**7236002  
Repairs to BEQ 4310**

**MCAS Cherry Point, NC  
AMENDMENT #0002**

Amendment 0002 is being issued to respond to pre-award RFI.

RFI Responses:

12866252

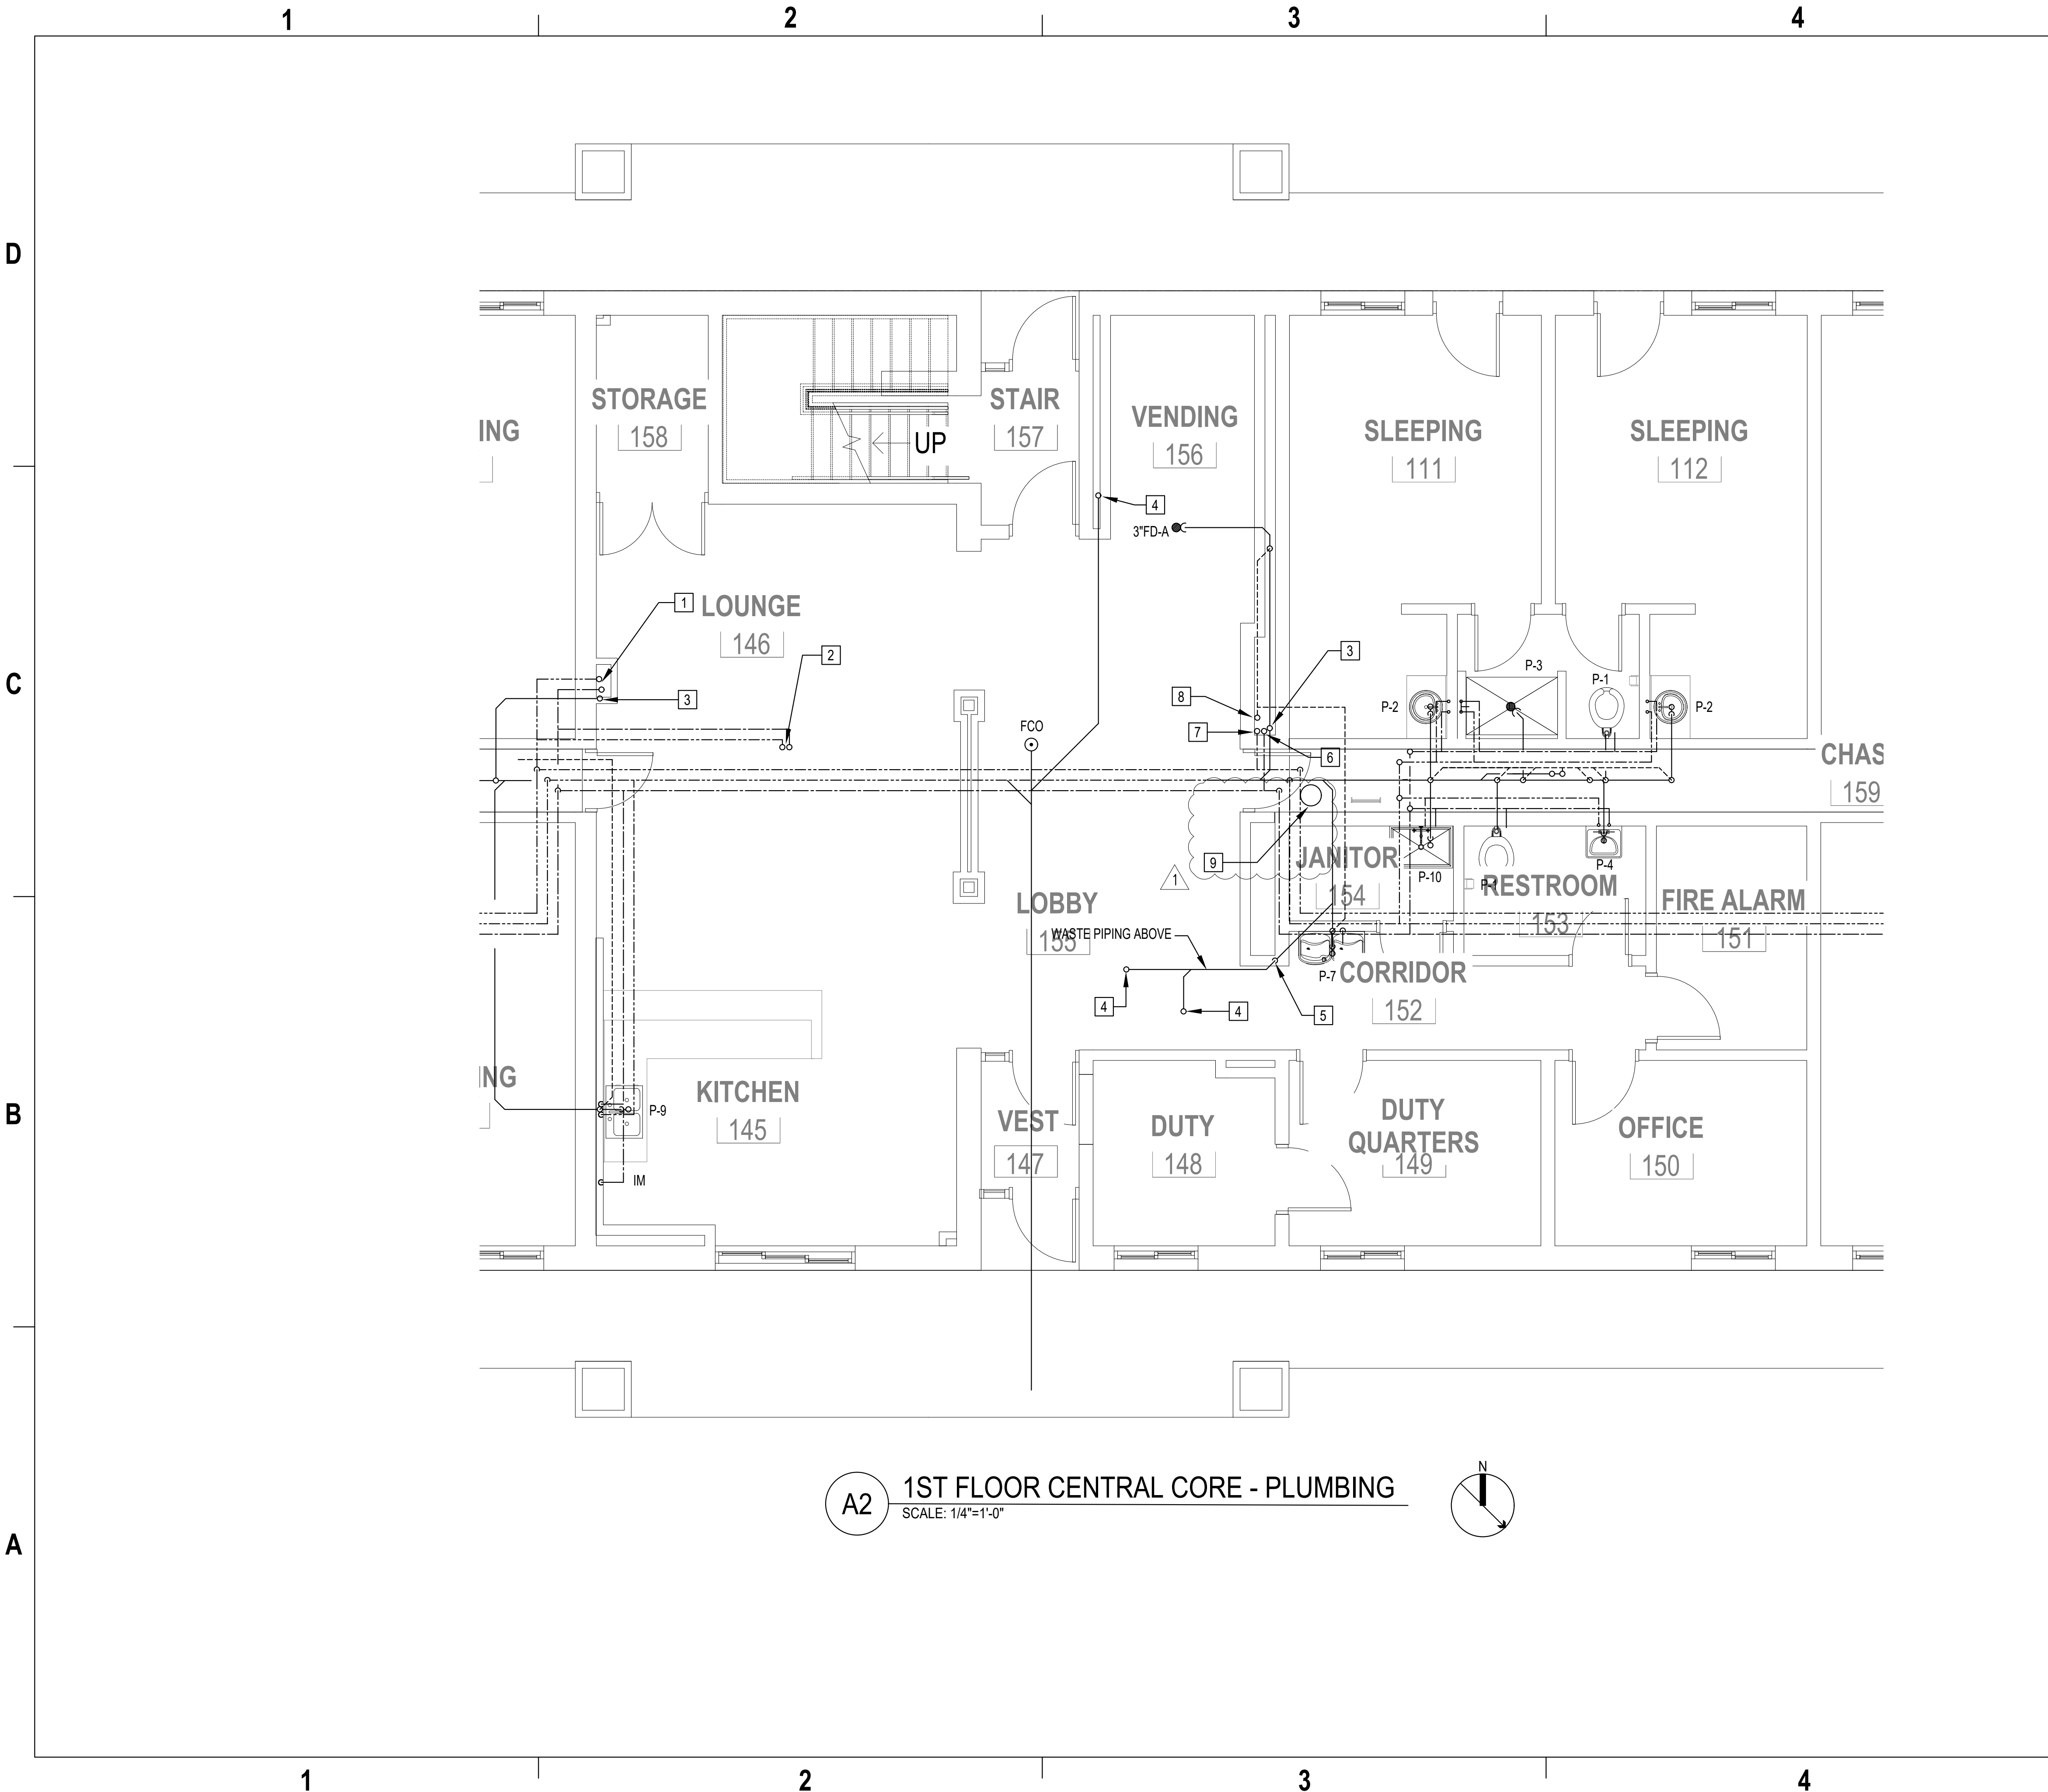
1. I noticed there is an existing sump pump located on the 1<sup>st</sup> floor within the corridor area that is not shown within the drawings to be demolished or replaced. The sump pump I am referring to is not associated with the steam pit. Is this sump pump to be removed/replaced? If so, may we get this sump pump added to the drawings, plumbing schedule, and specifications if it is to be different than what is already listed in the bid documents so that all bidders are aware of removal/replacement?

#	RESPONSE TO RFI #2	DATE	APPR
1706122

*Response: The sump pump spec will be the same as the one shown on the plans and details for the steam pit. It shall be removed and replaced. See drawings 12866247 and 1286652 revised 17 October 2022 that show the sump pump in question. Submit proposals in accordance with RFP, Specifications, Drawings and all amendments.*

- 1 3/4" CW AND HW UP.
- 2 1" CW AND HW UP.
- 3 4" WASTE UP.
- 4 2" WASTE UP.
- 5 2" WASTE DOWN.
- 6 2" CW UP.
- 7 1" HW UP.
- 8 3" VENT UP.
- 9 NEW SUMP PUMP.
